South Texas Project Electric Generating Station P.O. Box 289 Wadsworth, Texas 77483

U7-C-STP-NRC-090074

South Texas Project  
Units 3 and 4  
Docket Nos. 52-012 and 52-013  
Response to Request for Additional Information

Attached are responses to NRC staff questions included in Request for Additional Information (RAI) letter numbers 76 and 89 related to Combined License Application (COLA) Part 2, Tier 2, Section 6.2 and Appendix 3B.

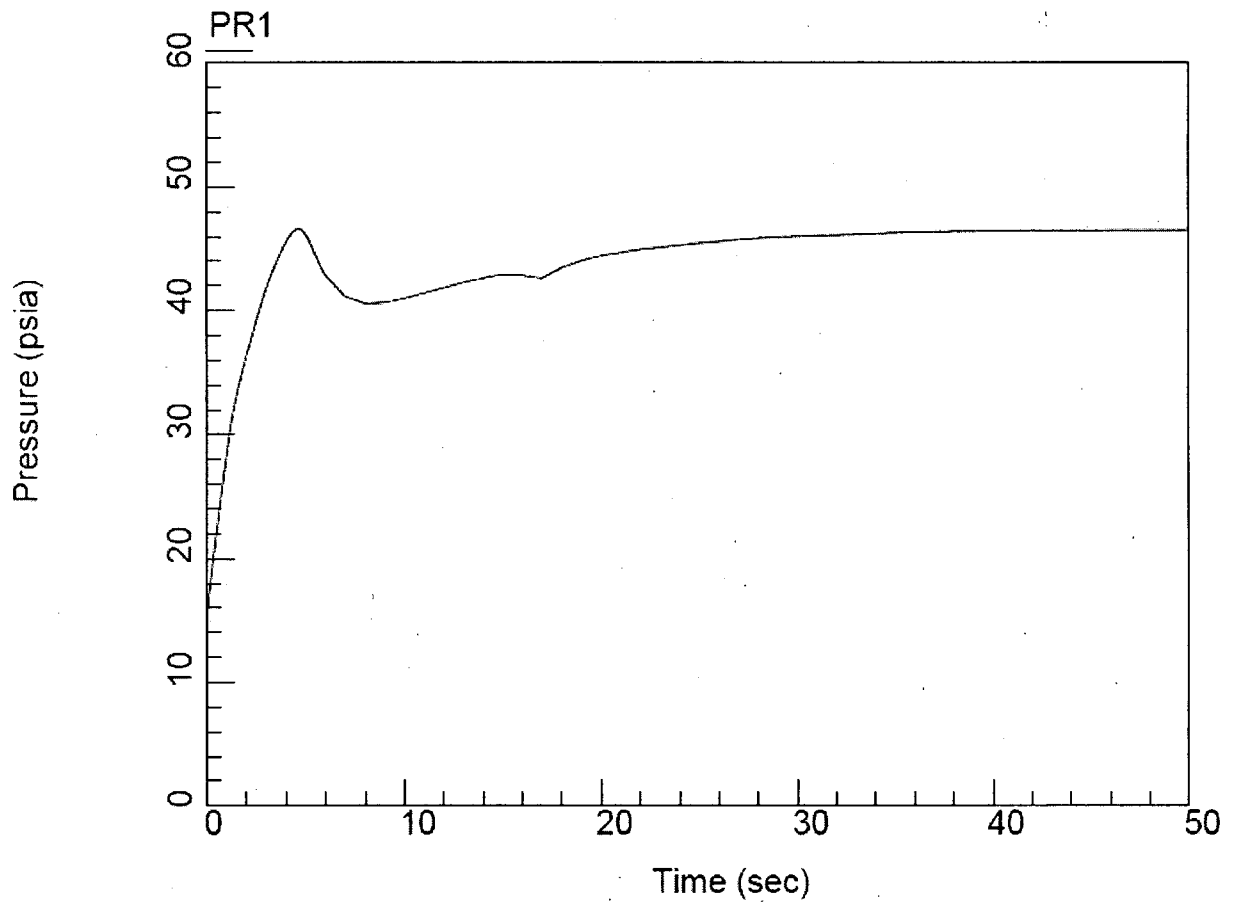
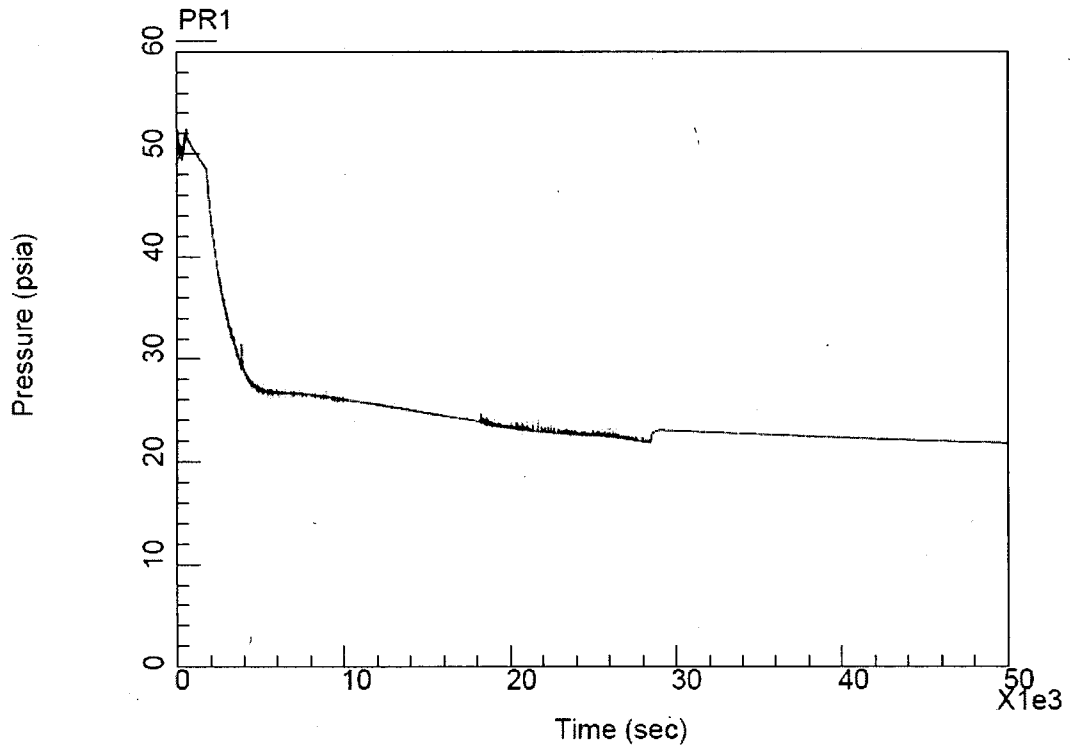
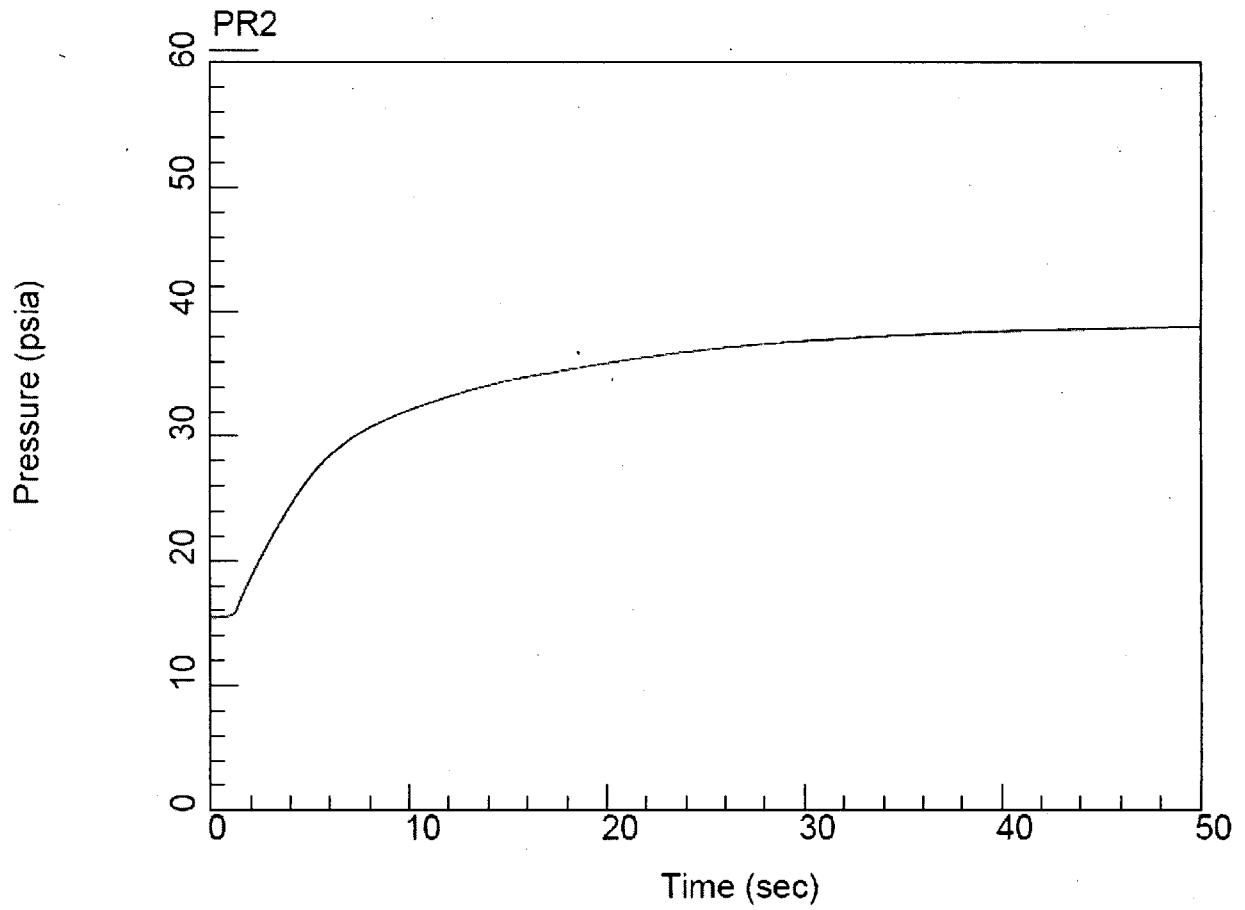
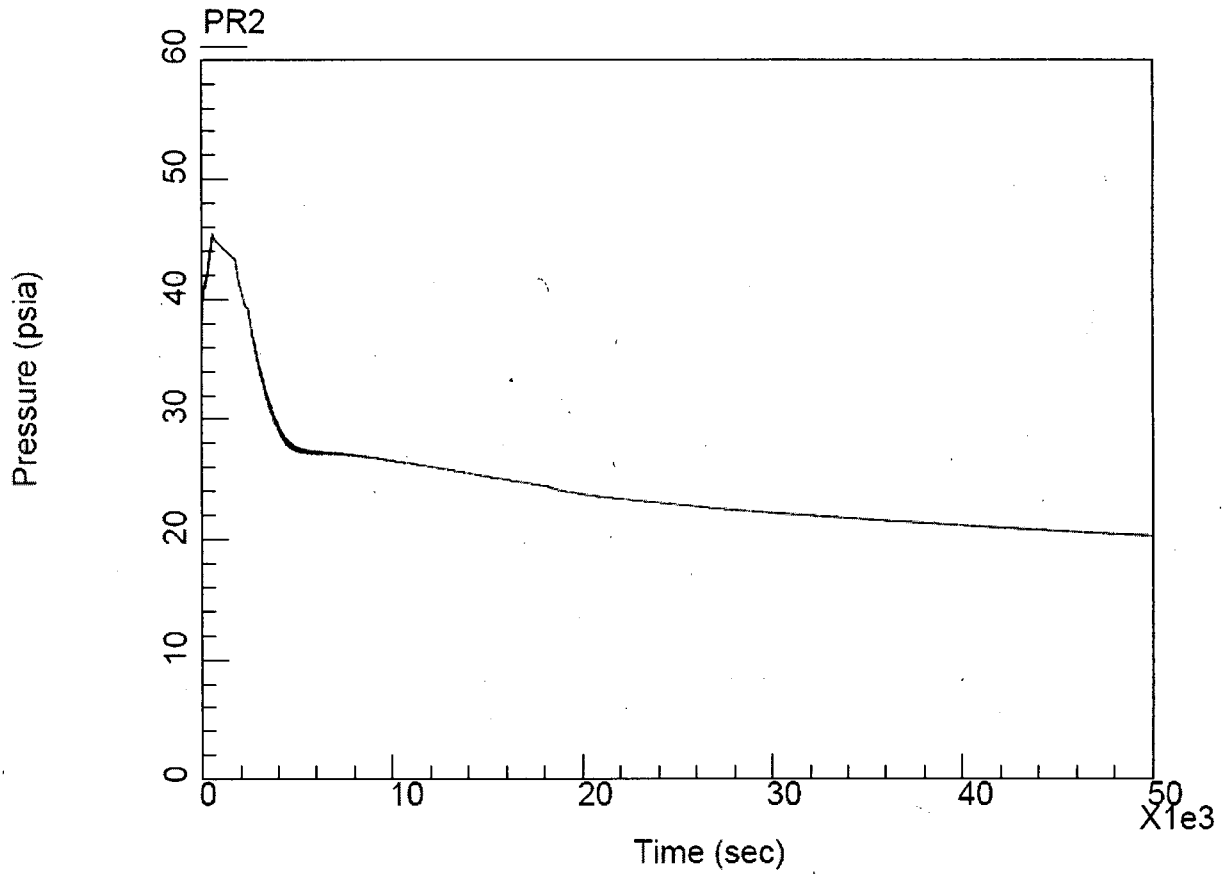
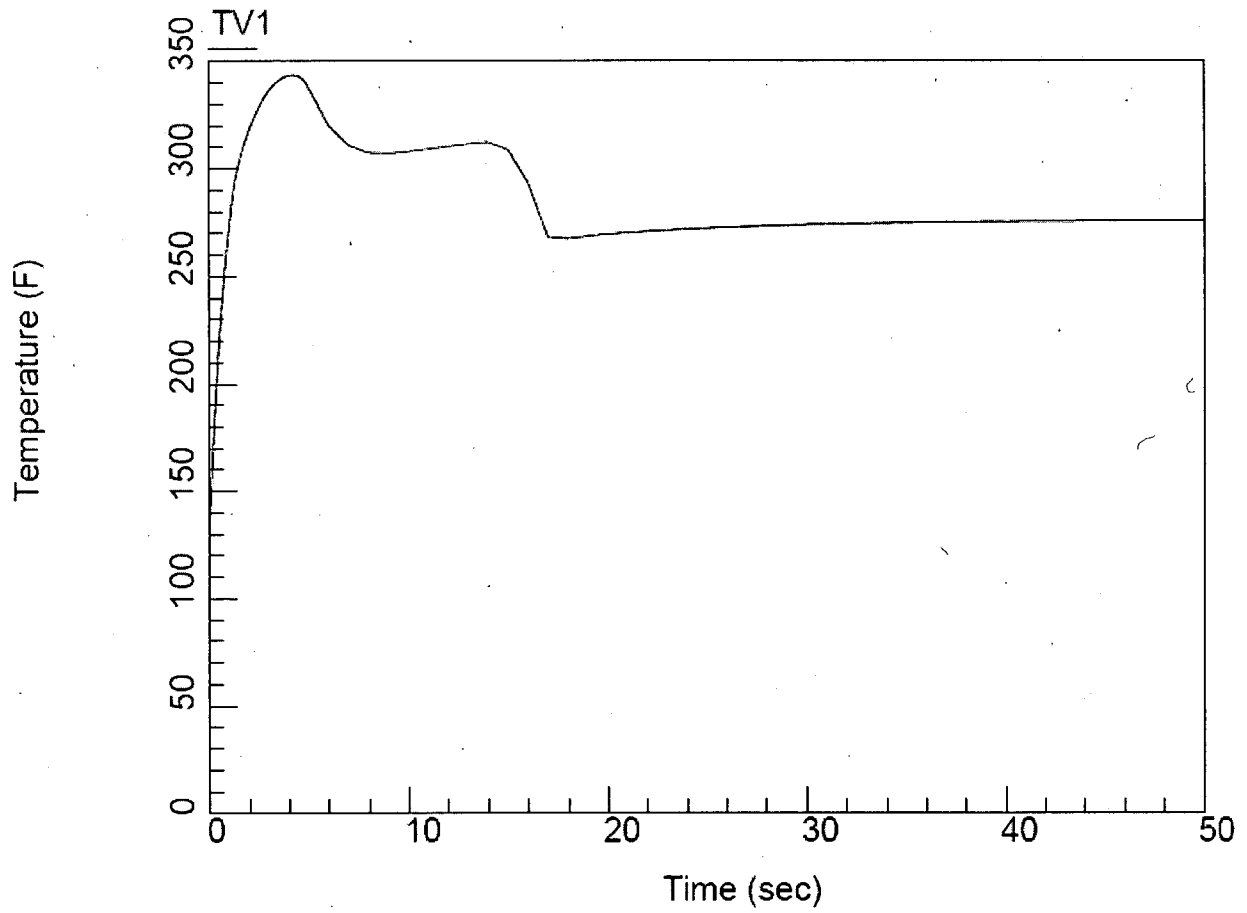
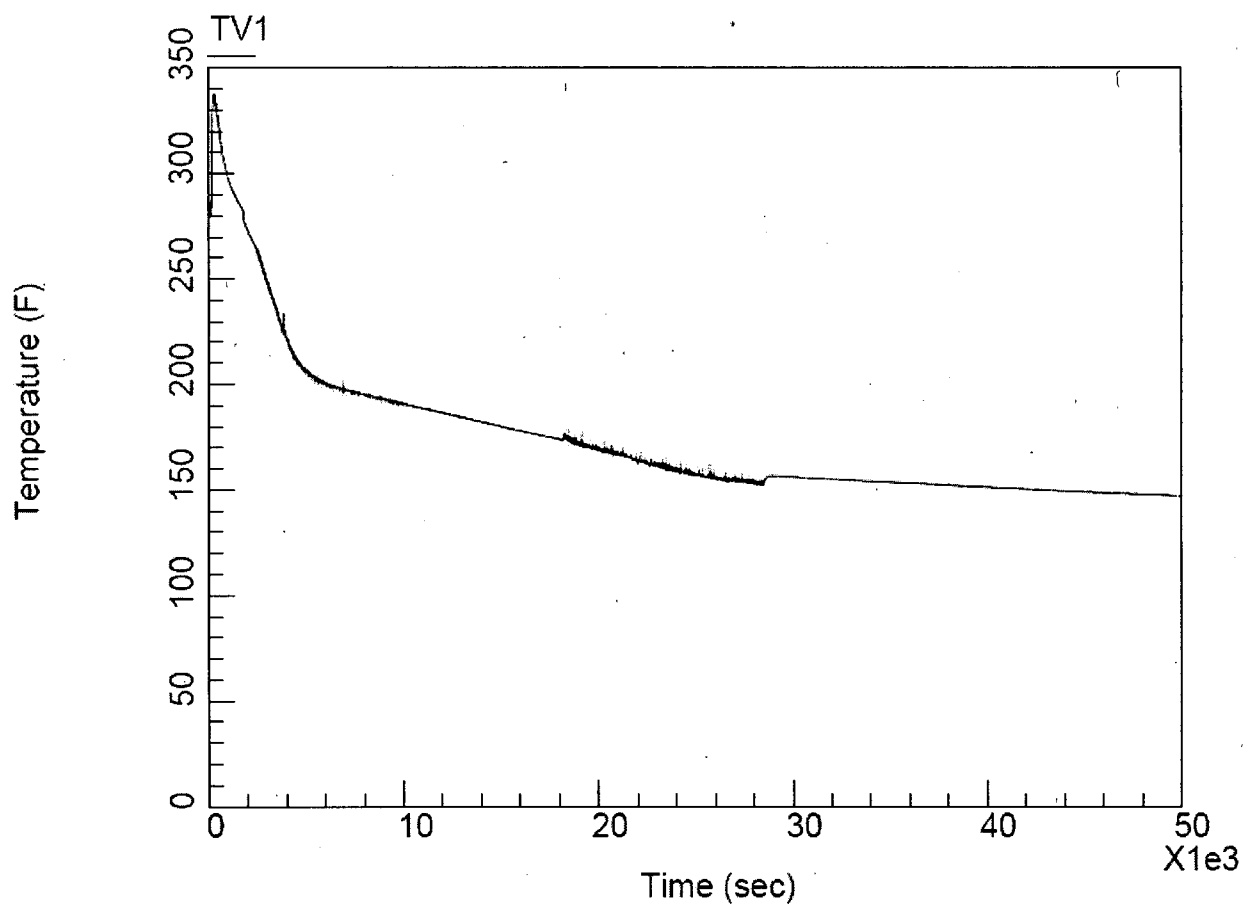
- (e) Main Steam Line Break (MSLB):
- A figure showing the containment pressure and temperature response (i.e., Figures 6.2-12 and 6.2-13 in [reference 2] STP COLA with the time axis varying from 0.0 to 30 min)

- (d) For the first bullet item, the requested FWLB figures and curves are provided in Figures 2 through 9. The figures provide results for both the short term (0-50 sec) and the long term (0-13.9 hours) analyses.
- For the second bullet item, the decay power curve in Fig. 6.3-11 is not used in the containment analysis but rather is used for the ECCS analysis. Consequently, the normalized power level for that Figure would not have any bearing on the containment analysis results. The decay power curve used for the containment analysis is based on 102% power.
- (e) The requested MSLB figures are provided in Figures 10 through 17. These figures provide results for both the short term and the long term analyses.
